**EPC PACKAGE FOR LARA SUPER THERMAL POWER PROJECT, STAGE-II (2x800 MW)**  
**Amendment No. 04 to Technical Specifications Section-VI of Bidding Document No.: CS-9587-001R-2**

Doc. No.: CS-9587-001R-2-TECH AMDT- 04	LARA SUPER THERMAL POWER PROJECT STAGE-II (2X800 MW)	Amendment No. 04 to Technical Specifications Section-VI
--	--	---

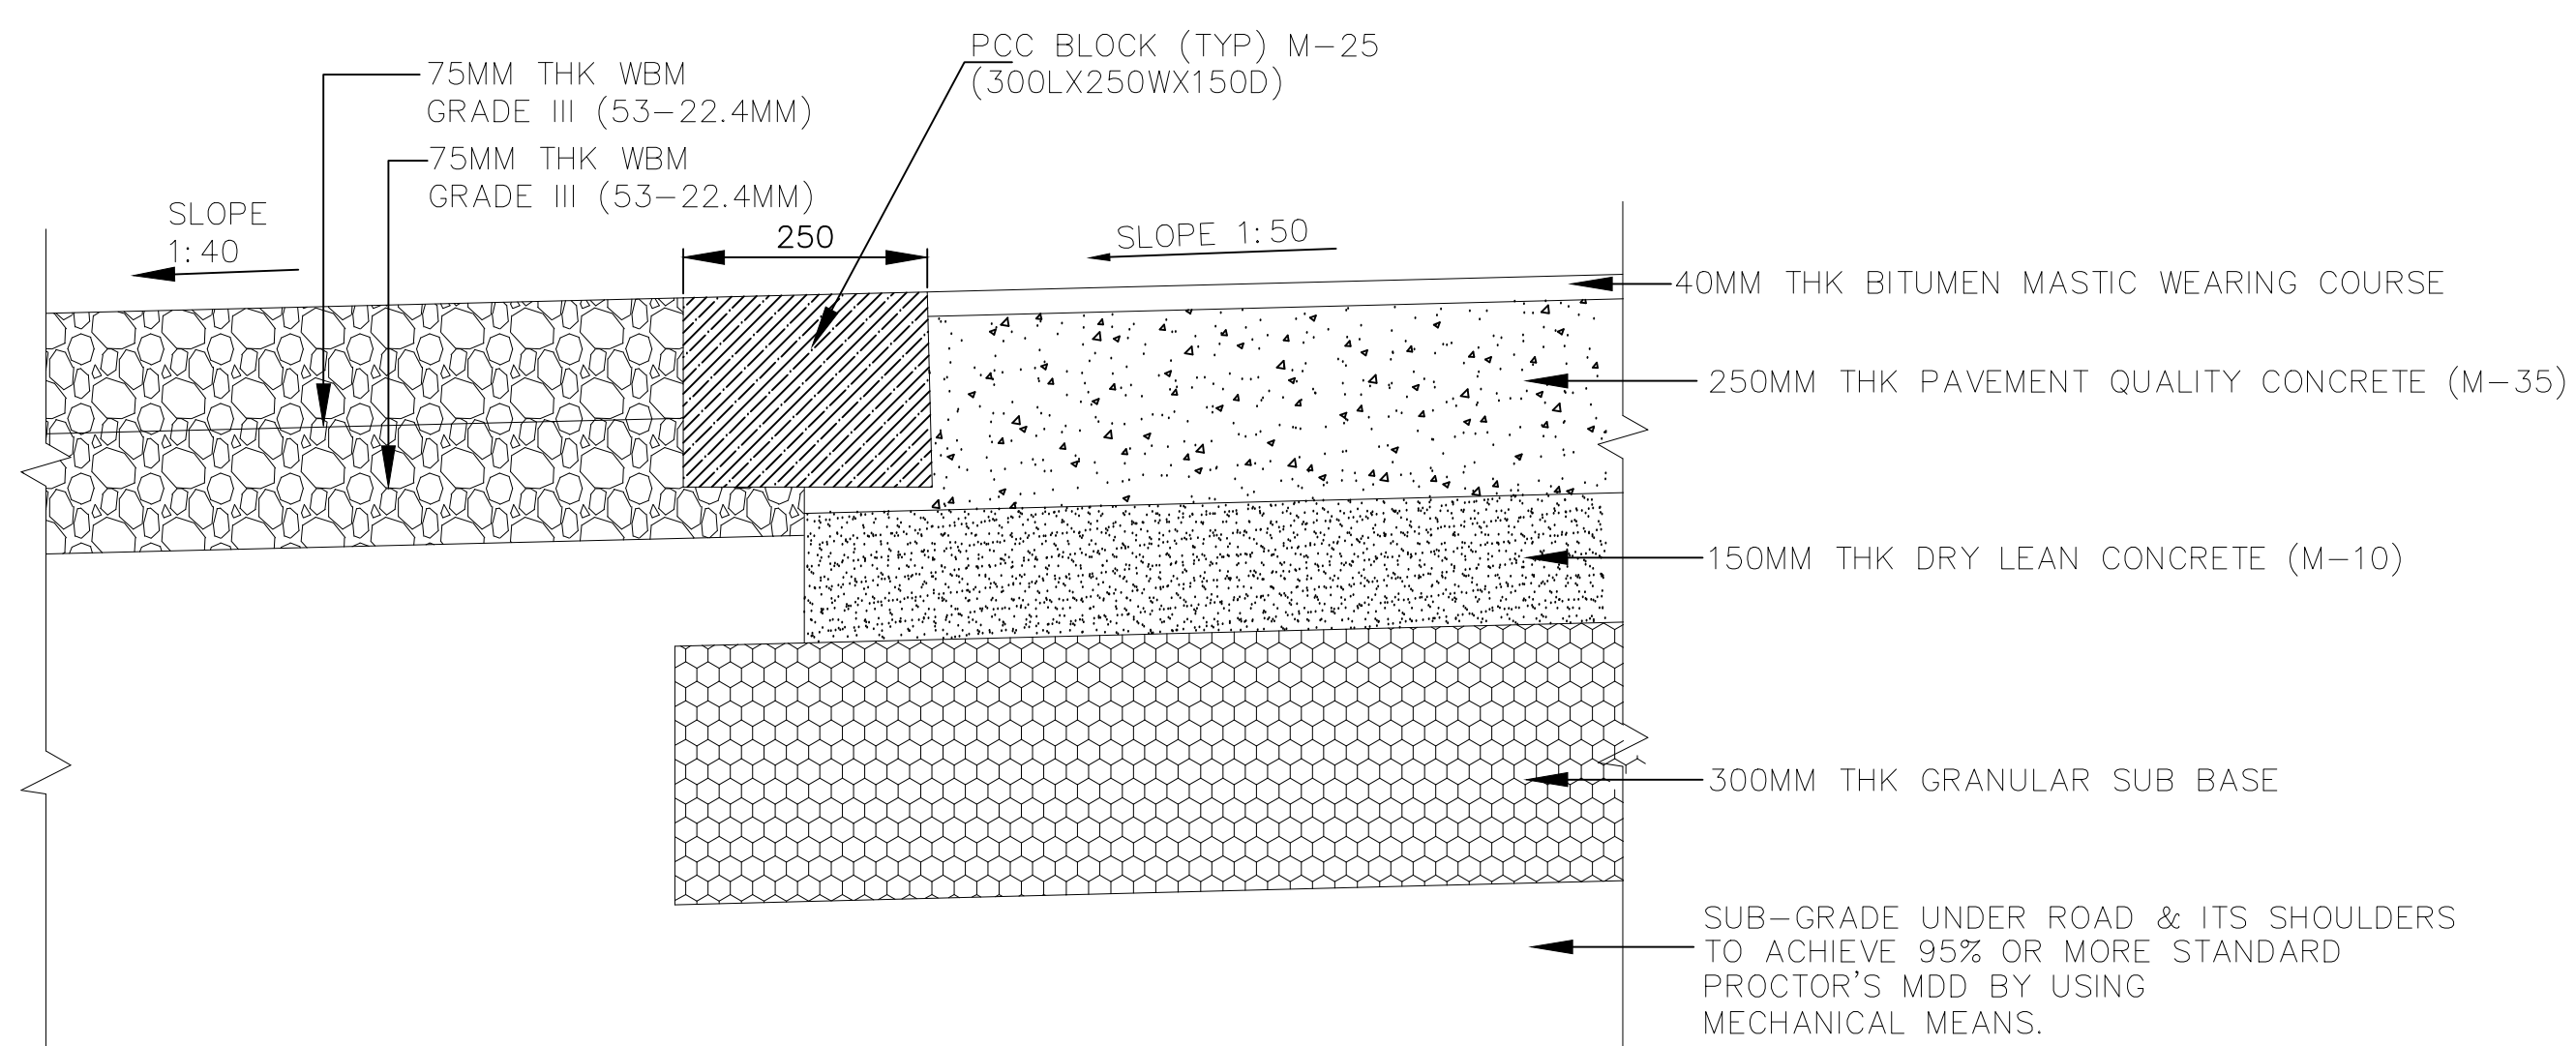
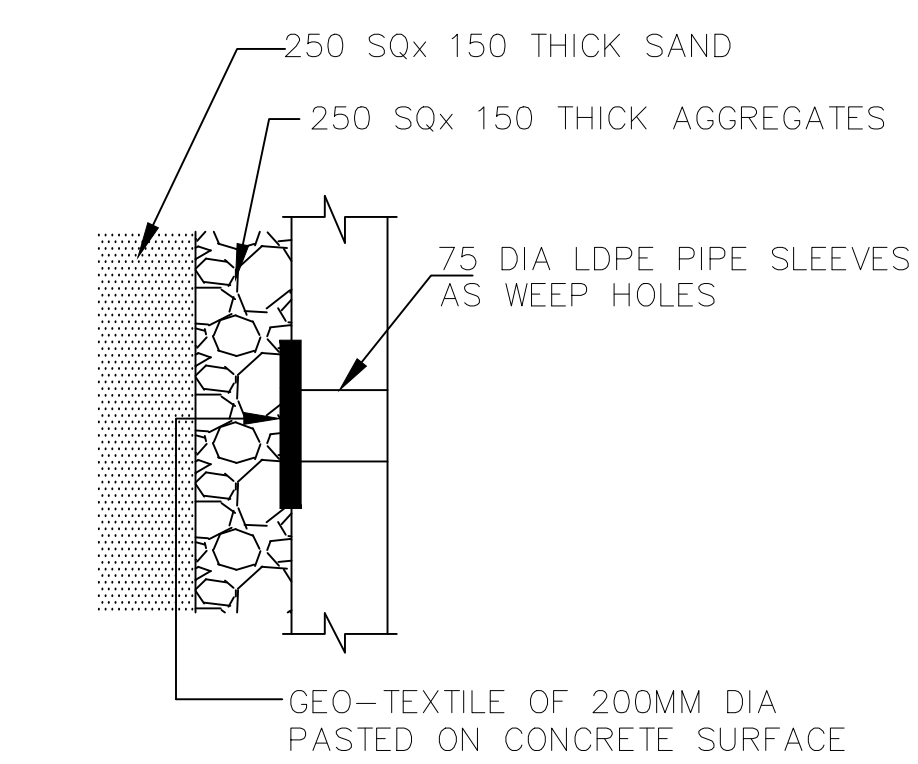
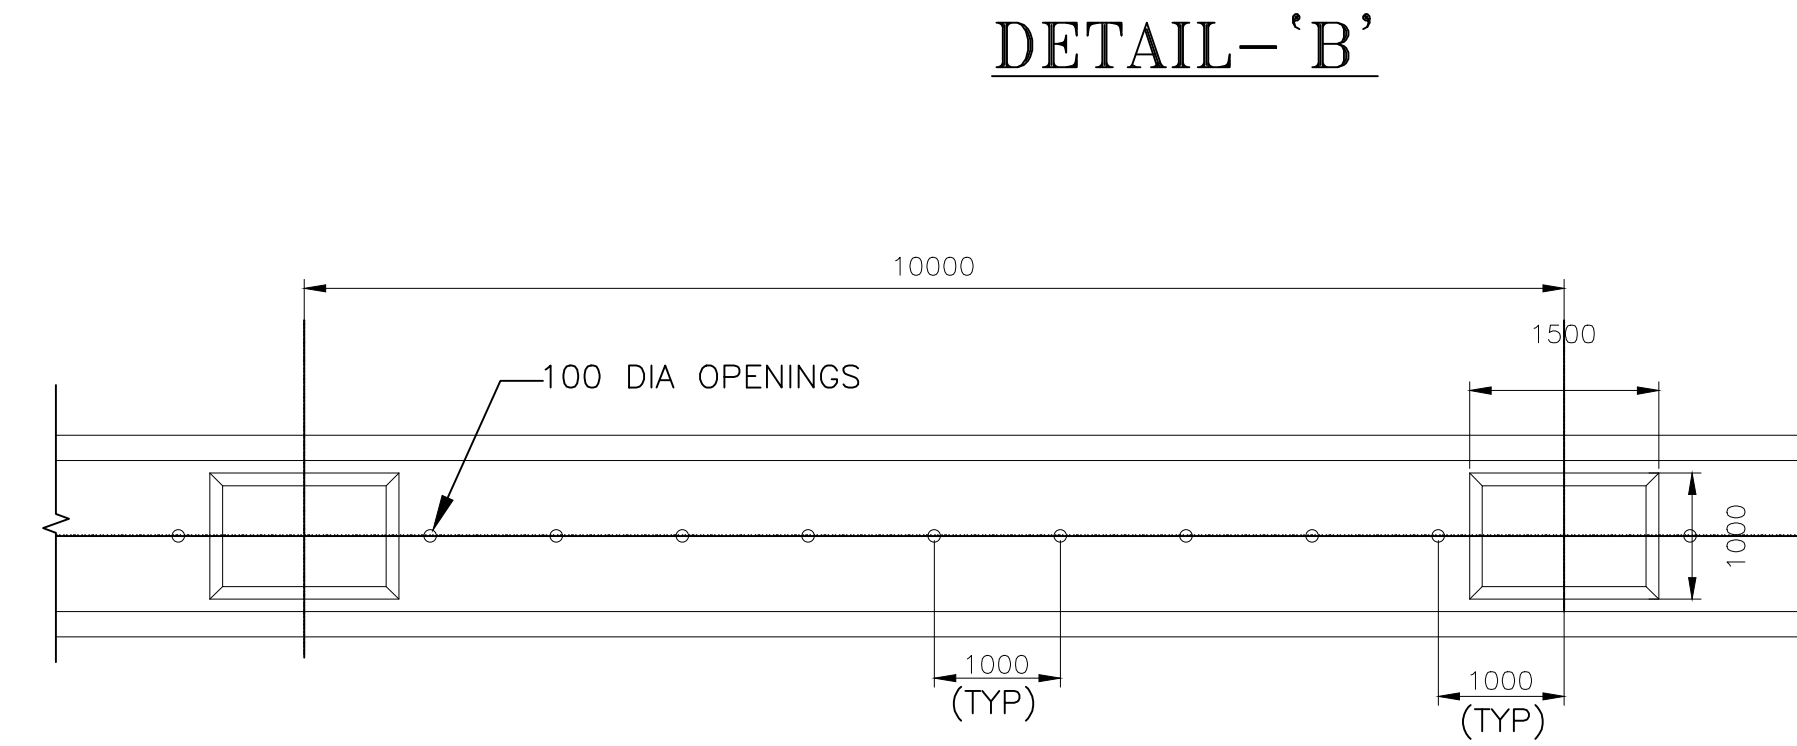
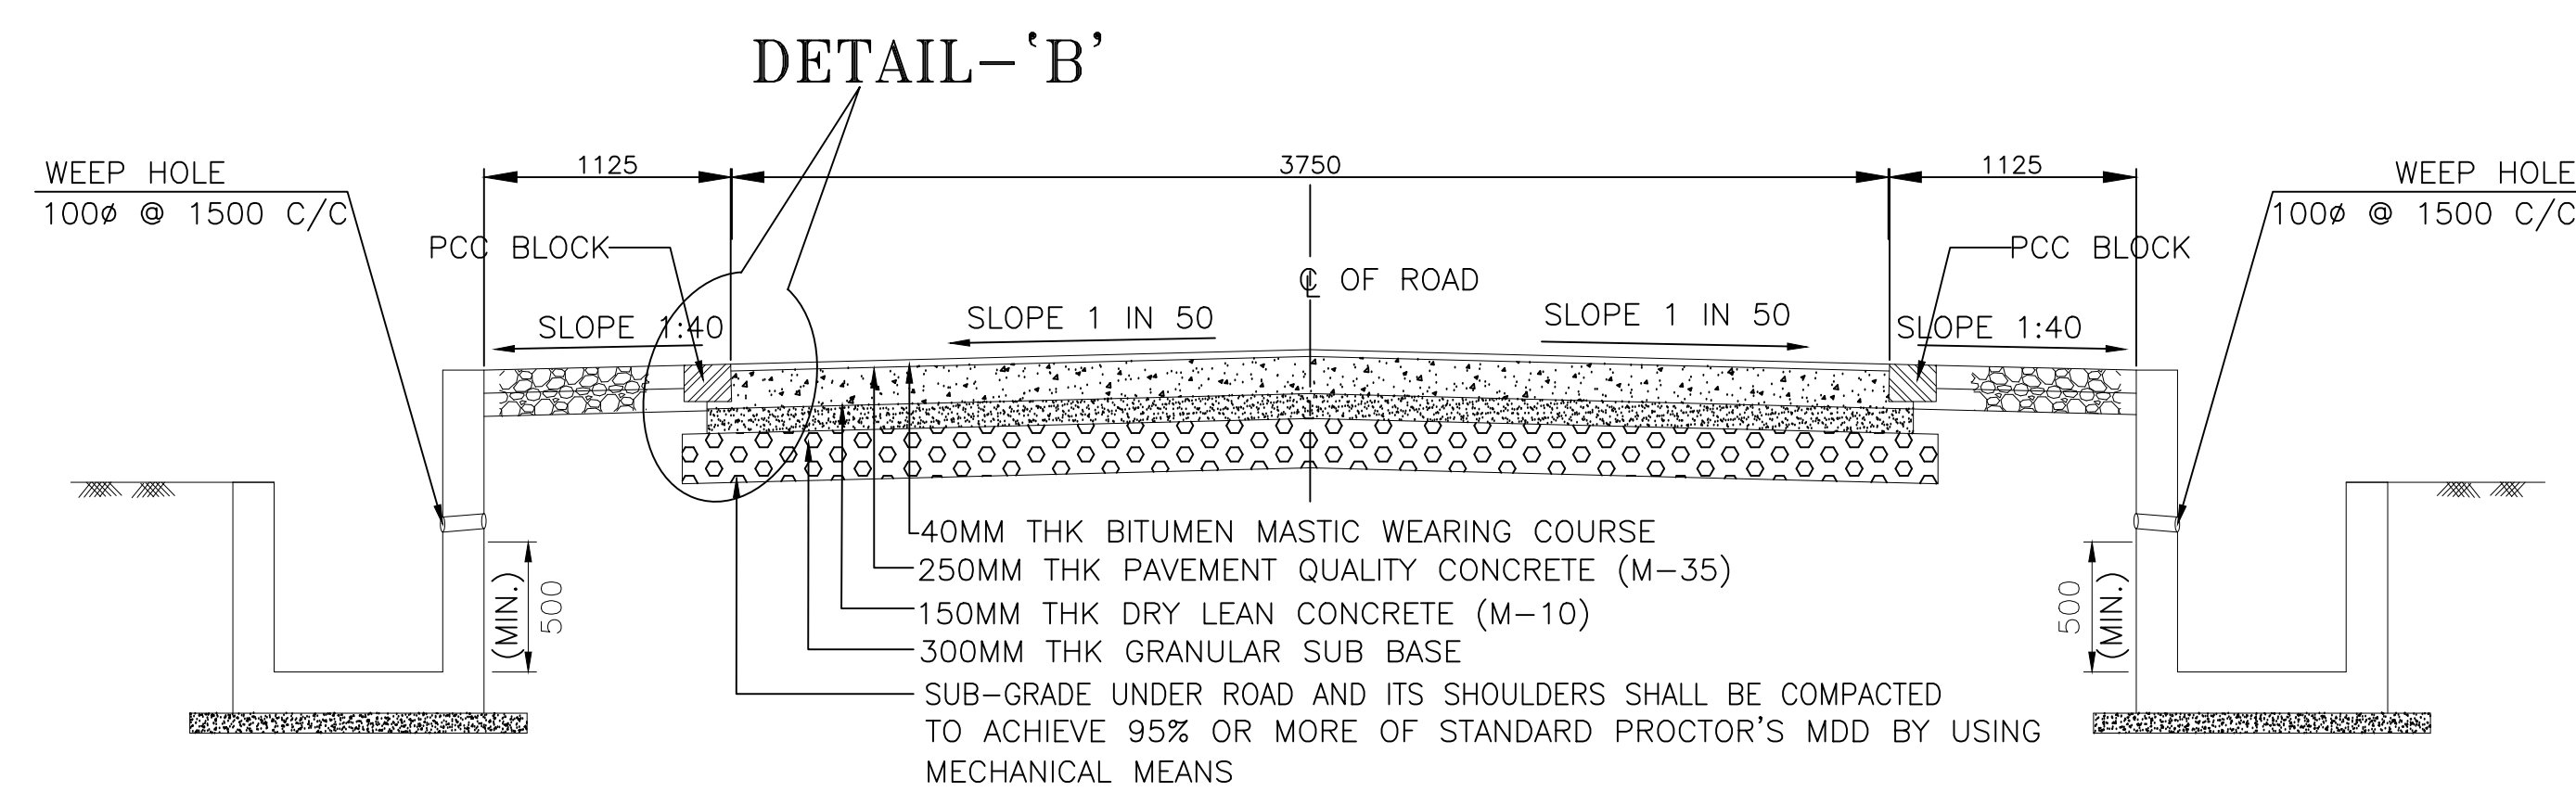
1. ALL DIMENSIONS ARE IN MM AND LEVELS ARE IN METRES.
2. TOP OF ROAD CREST LEVEL SHALL BE 350MM ABOVE THE FINISHED GROUND LEVEL (FGL).
3. THE CREST LEVEL OF THE ROAD SHALL CORRESPOND TO THE LEVEL AT THE TOP OF CONCRETE PAVEMENT AT THE CENTRE OF ROAD.
4. CAMBER SHALL BE PROVIDED AT SUBGRADE LEVEL.
5. ALL EXCAVATION WORK, BACK FILLING, LAYING OF VARIOUS LAYERS OF ROAD CONSTRUCTION SHALL BE AS PER TECHNICAL SPECIFICATIONS.
6. NO MATERIAL WITH CBR VALUE LESS THAN 100% SHOULD BE USED IN BASE CONSTRUCTION.
7. THE SHOULDERS ON BOTH SIDES OF THE ROAD SHALL BE PROPERLY COMPACTED.
8. ROAD CONSTRUCTION SHALL BE DONE AS PER DETAIL DRAWING OF ROAD.
9. CONCRETE SHALL BE OF GRADE M25 FOR DRAINS AND CULVERTS AS PER IS: 456-2000.
10. CONCRETE MENTIONED IN ROAD PAVEMENT SHALL BE READ AS GEO-POLYMER CONCRETE
